Index 711-003 Interchange Markings

COMMENTS AND RESPONSES

INDEX 711-003	SHEET 5 of 8
------------------	-----------------

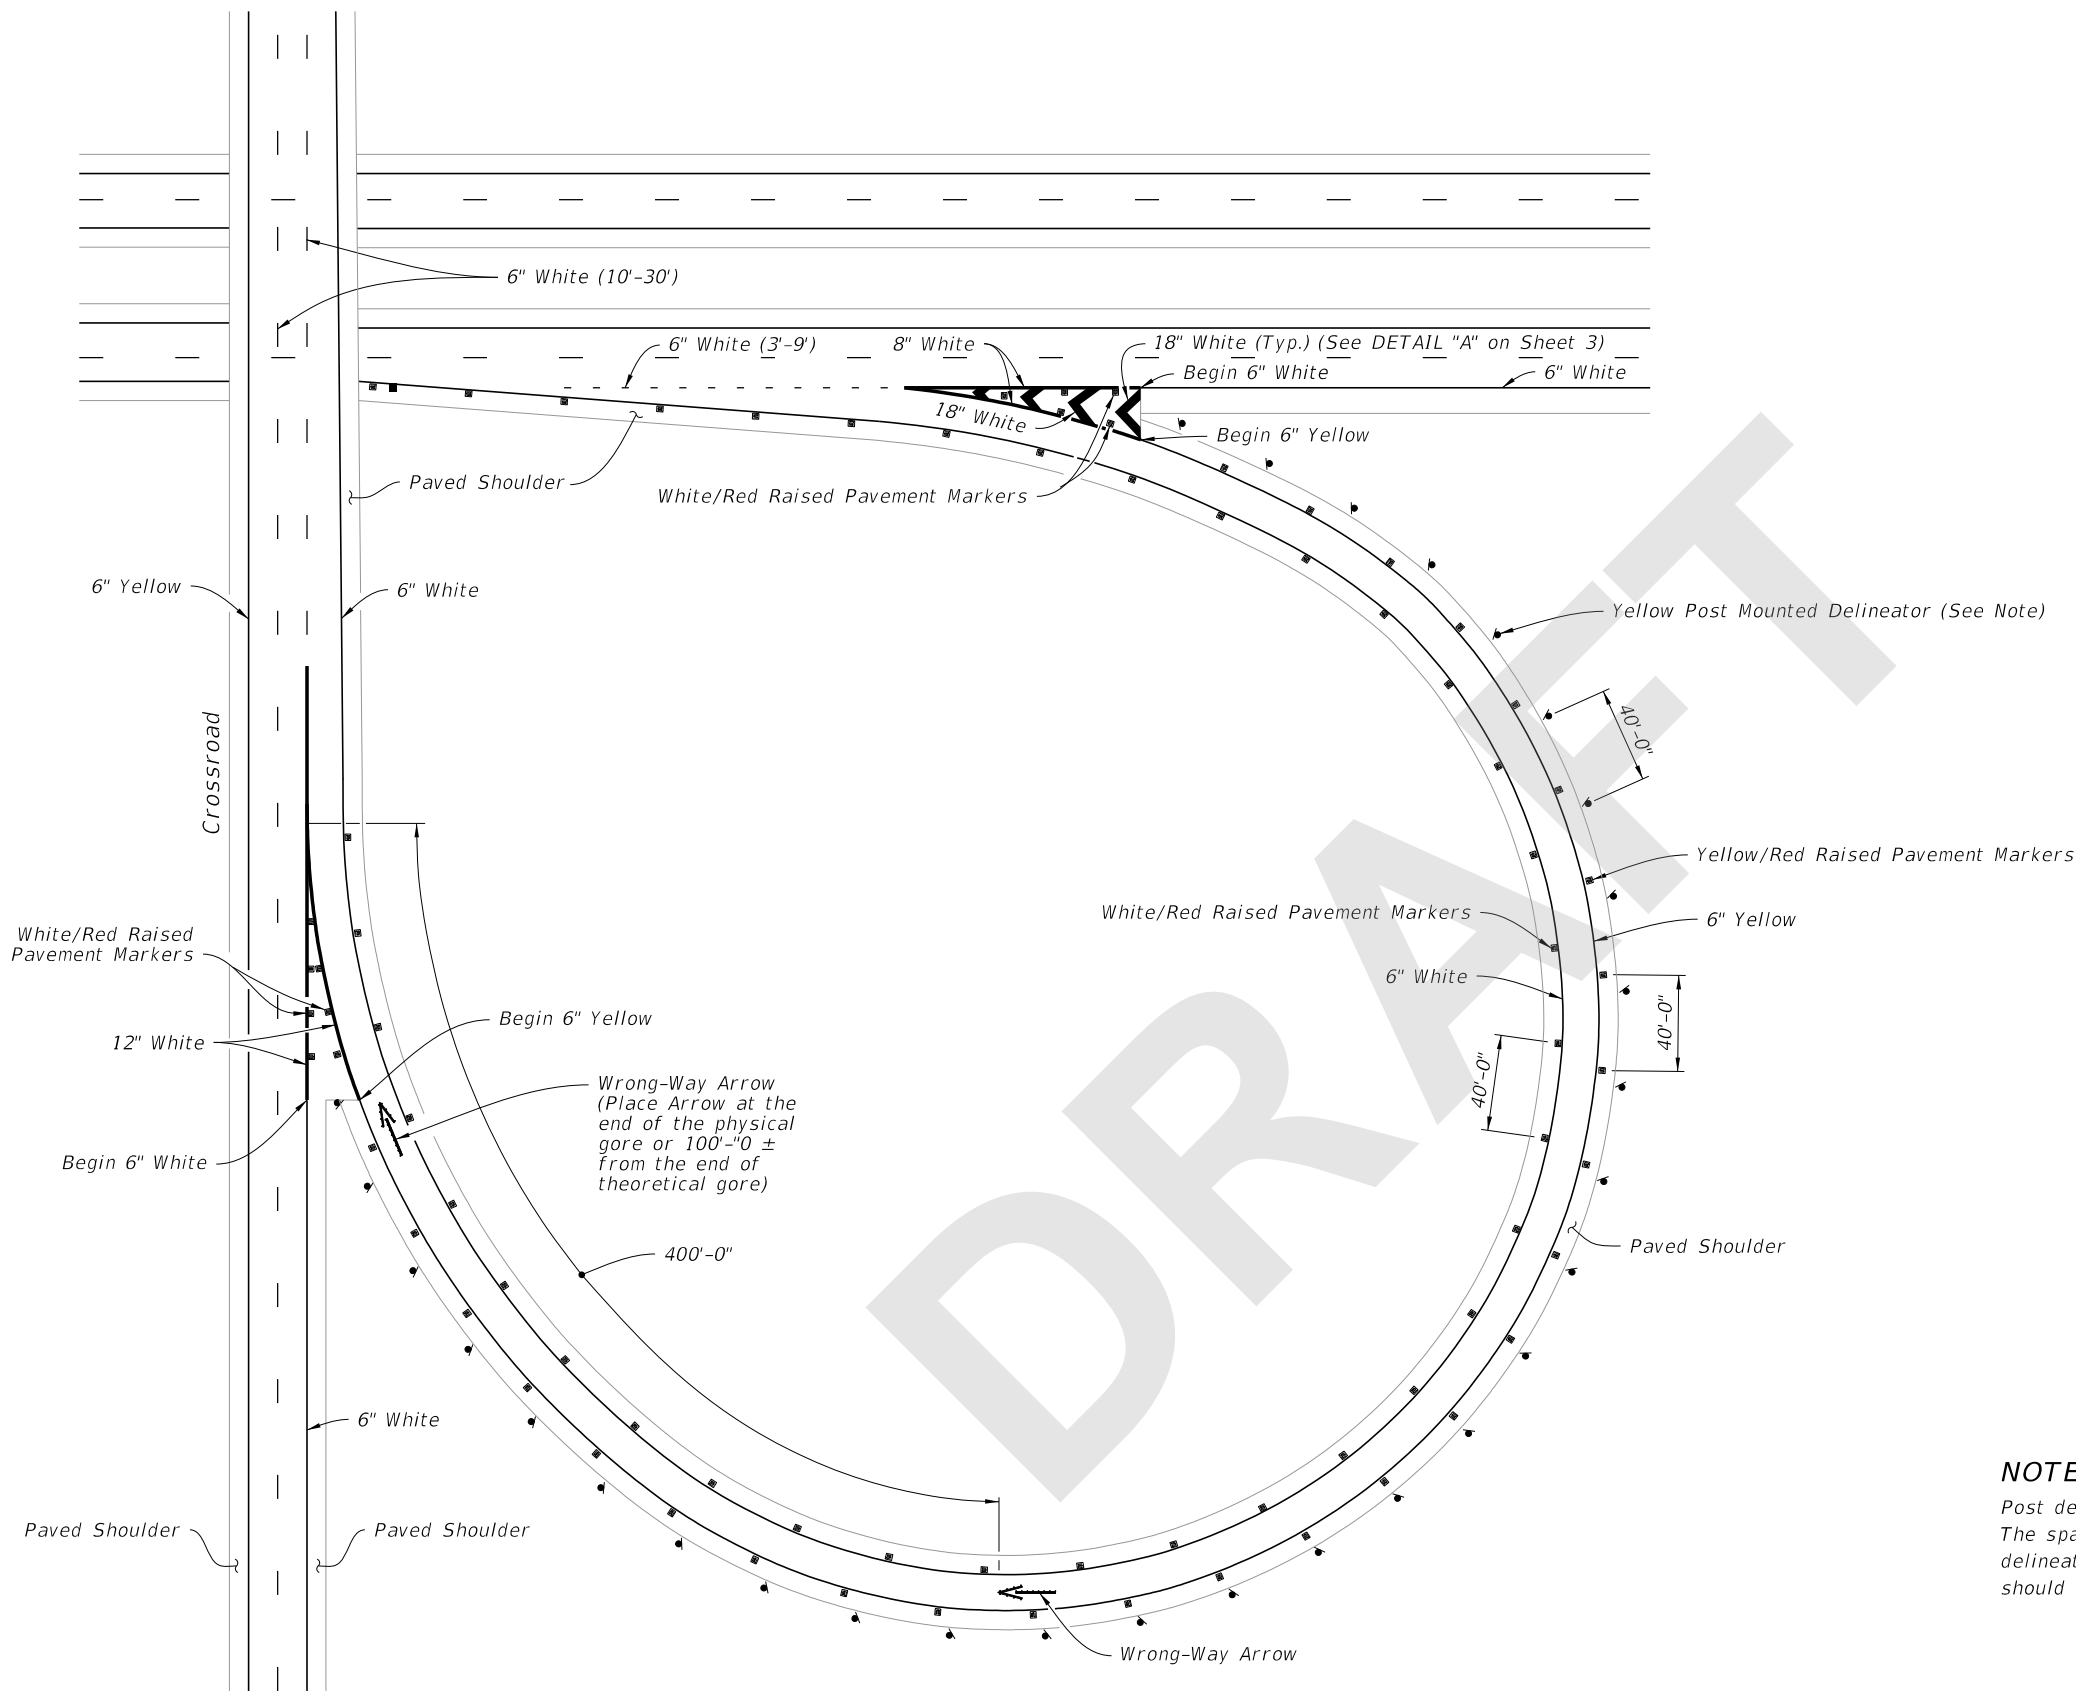
COMMENT: On the 711-003 draft, the "See Note 1" remark was removed along with the "See Detail C." Might be a little confusing since Note 2 is still referenced for the delineators, and there is a second Wrong Way arrow that Note 1 does not apply to.

COMMENT: The Note is specific to the first Wrong-Way Arrow closest to the gore. I recommend we go back to the original callouts shown prior to the current note (i.e., circa 2016). Please check that the 100' option from the arrow near the gore was initially removed (i.e., Note 1 only states to place it "at the gore" but the older standards had 100' option from the theoretical gore) . Also, Note 1 on Sheet 6 only applies to one of the arrows (see 2016 Design Standards). This needs to be corrected.

RESPONSE: Agree this will be updated.

Change made to Index: Note 1 on Sheet 5 will be deleted, and the information moved to the first Wrong-Way Arrow callout.

RESPONSE: Agree. The Wrong-Way Arrow callout for the first arrow will be updated to the previous version. Note 1 will be clarified to specifically point to the appropriate arrow.

Change made to Index: Note 1 on Sheet 5 will be deleted, and the information moved to the first Wrong-Way Arrow callout. The Wrong-Way Arrow callouts on Sheet 6 will be updated and Note 1 will be deleted.
